6855 CONSTITUTION AVE. STORAGE SITE  
 INDUSTRIAL DEVELOPMENT  
 REZONE PACKAGE  
 FOR JOHNSON DEVELOPMENT ASSOCIATES  
 LOT 1 OF THE EIGHT LINE SUBDIVISION  
 COLORADO SPRINGS, CO 80916

Project No: JDA000002.20  
 Drawn By: JRW  
 Checked By:  
 Date: 04/22/2022  
**LANDSCAPE COVER SHEET**

**L1.0**  
 Sheet 4 of 20

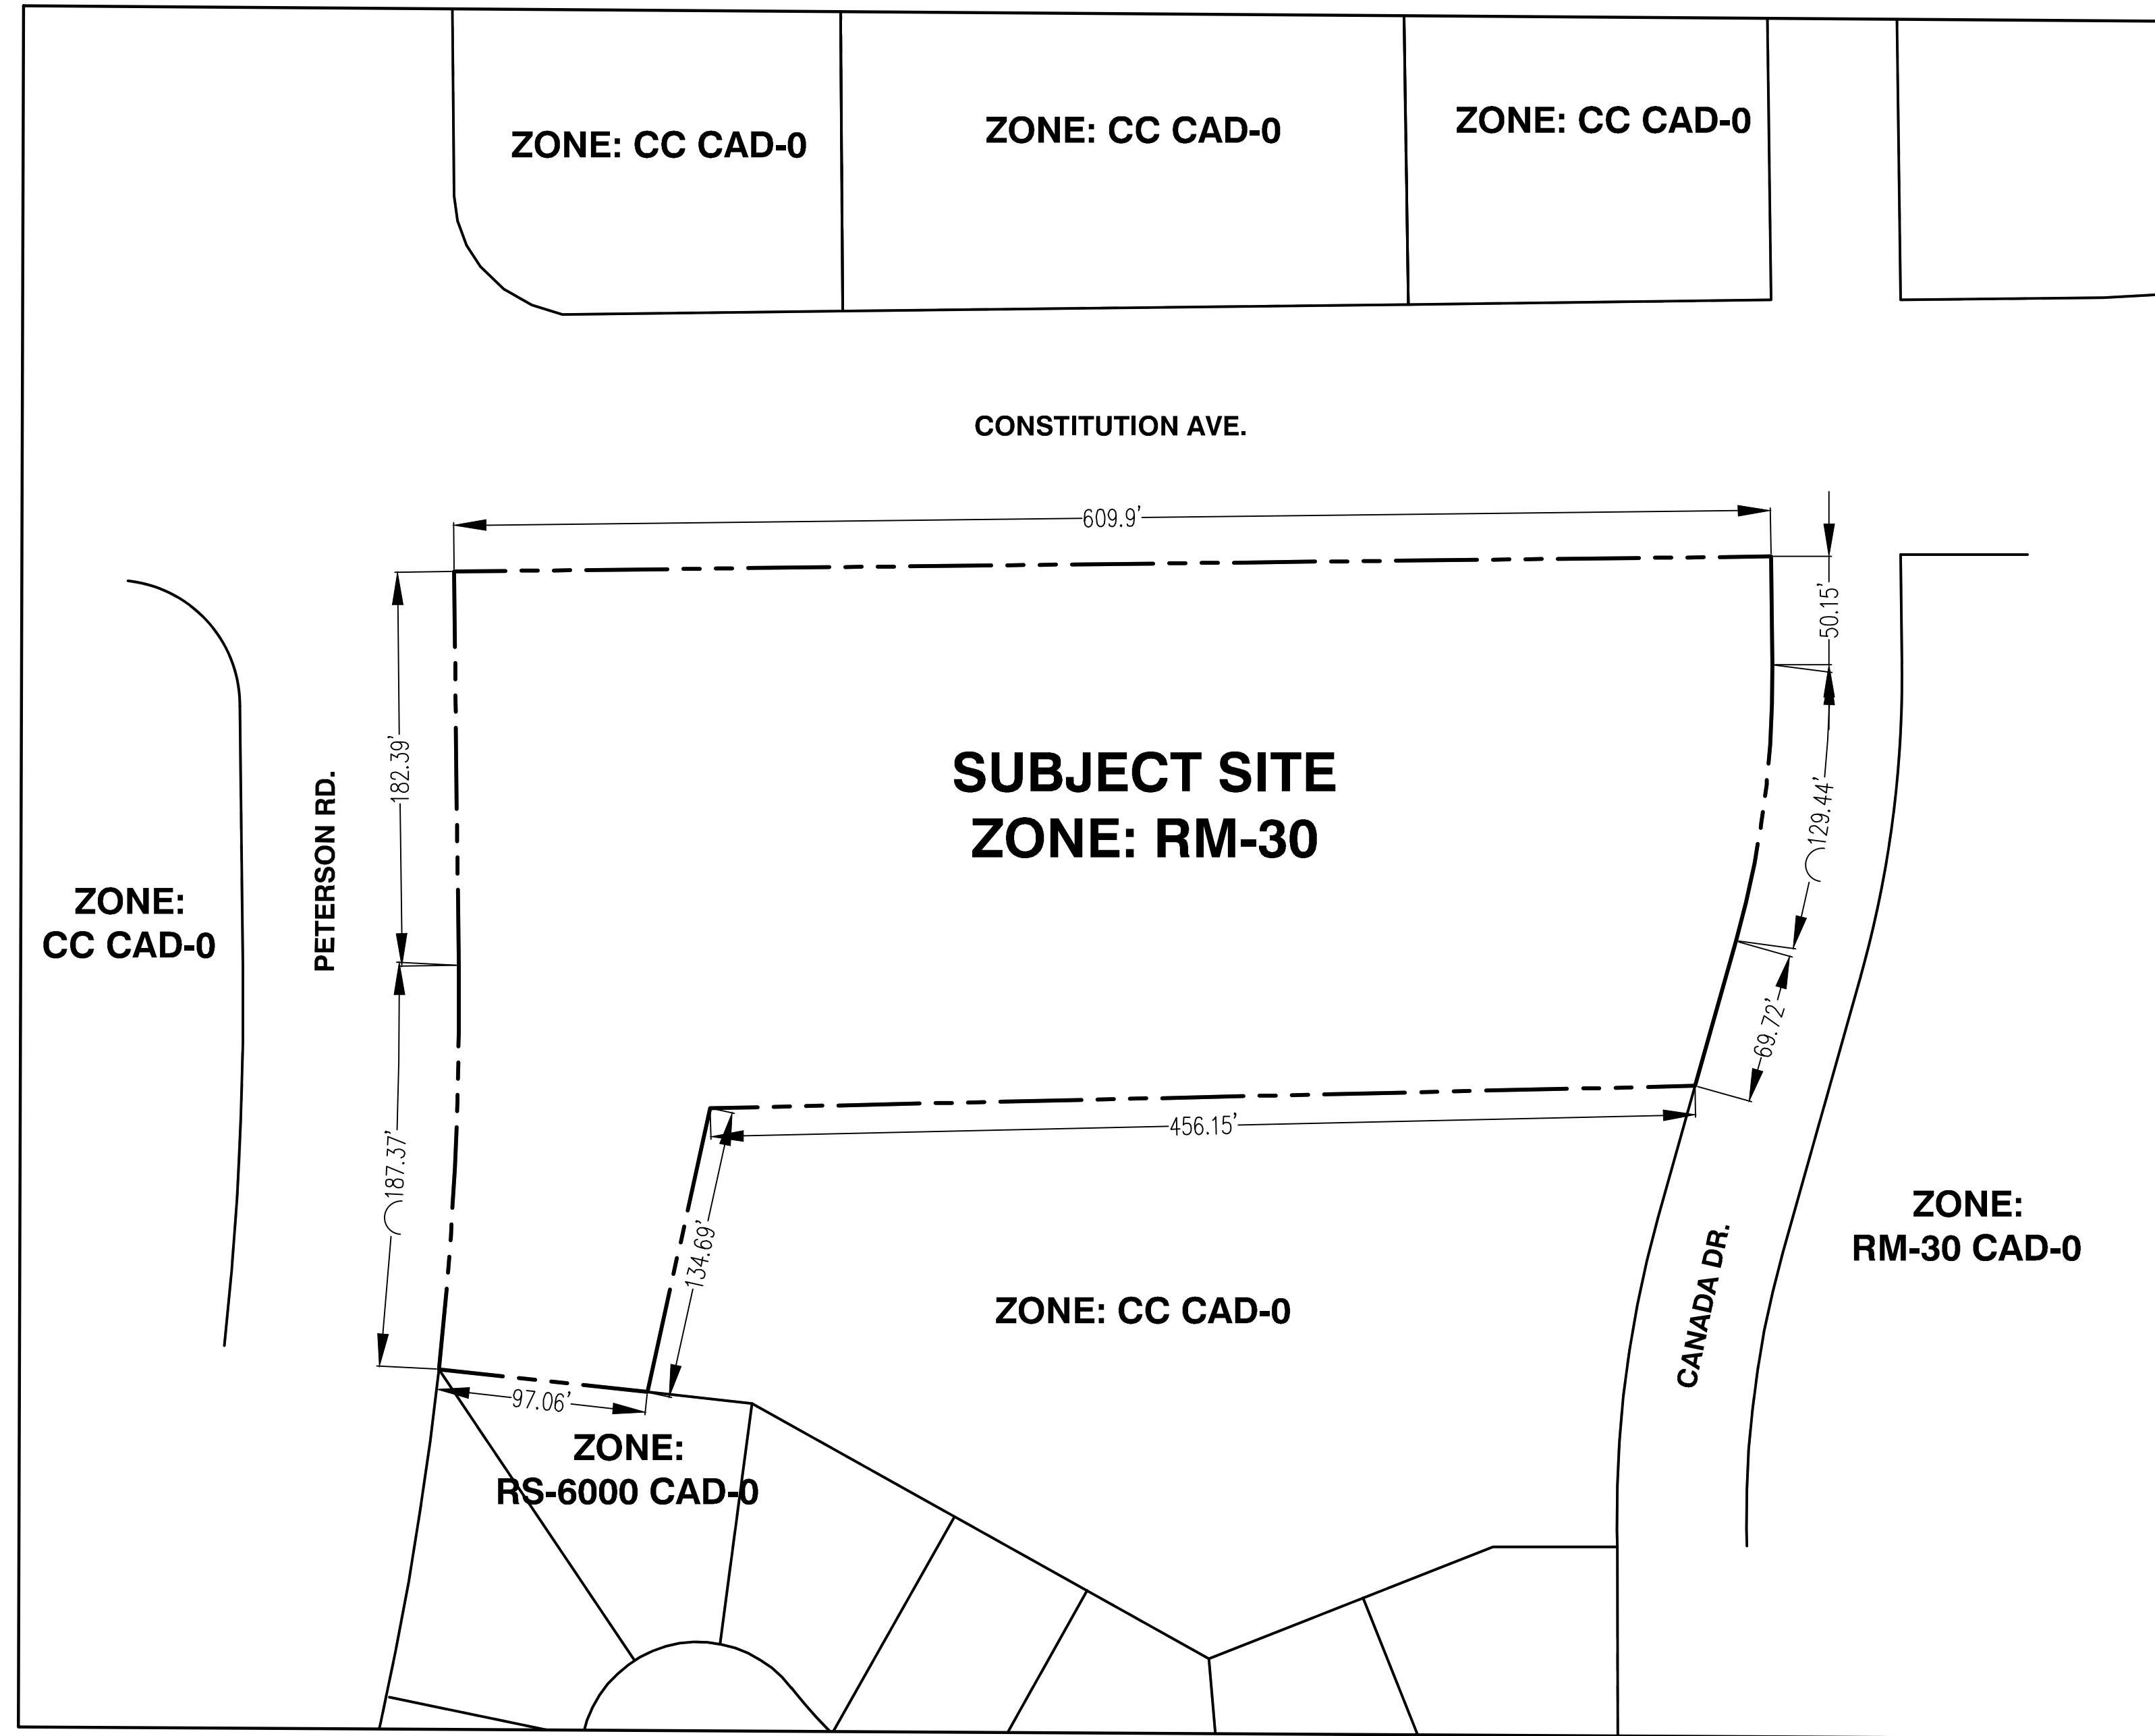
Unresolved version 5 comment from the letter intent:  
 Per version 5 comments, please change title to alternative landscape plans
